## SERVICE BULLETIN

**NUMBER:** 02-151-14R

**SUBJECT:** Revised Valve Train Parts to Reduce a Warm Engine  
 Tapping Sound from the Left Cylinder Head

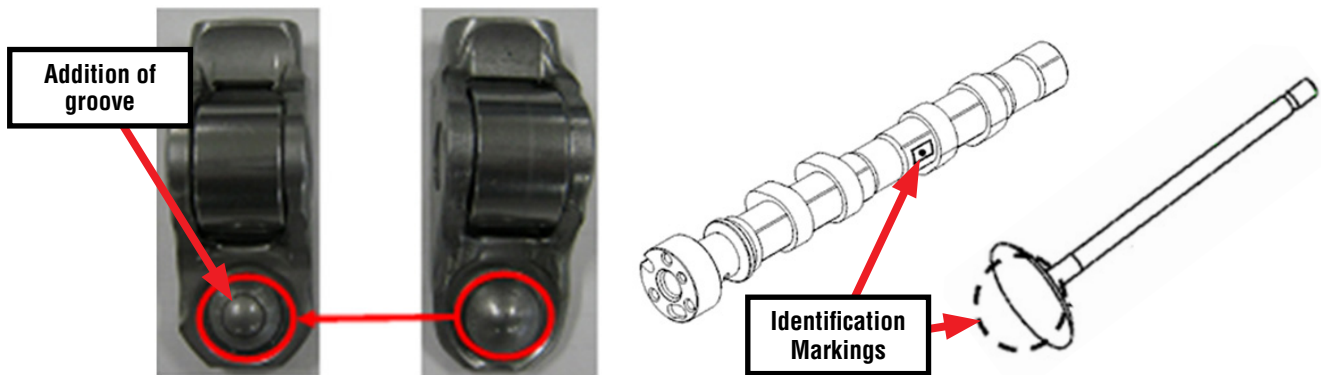
This bulletin announces the availability of revised valve train components developed to reduce a tapping sound (sometimes described as “a sewing machine type” sound) which may be heard coming from the left-hand (B2) side of the engine when the engine is warm. This bulletin does **not** address any cold engine or start-up sounds. The changes consist of:

- Design change to the valve rockers
- Camshaft profile change
- 1.65mm longer intake and 2.47mm longer exhaust valve stem lengths

The illustrations below show additional information about the changes to the valve rockers, camshafts and valves to help readily distinguish them from the previous version parts.

If you receive a customer concern of a tapping sound from the B2 cylinder head, confirm it is isolated to the B2 valve train area before proceeding with any repairs. Once verified, order and replace the intake and exhaust camshafts, the 4 intake valves, 4 exhaust valves, all 8 rockers and all 8 pivots. Refer to the service procedures outlined in the applicable Service Manual for installation.

**NOTE:** When setting the valve clearances, the intakes should be set to 0.13mm +0.02 / - 0.03 and the exhausts set to 0.22mm +/- 0.02. **These are revised clearance specifications and are not reflected in the Service Manual.**

**IMPORTANT:** Do not mix old and new parts together as it will become impossible to obtain intake valve clearances that are within specification.
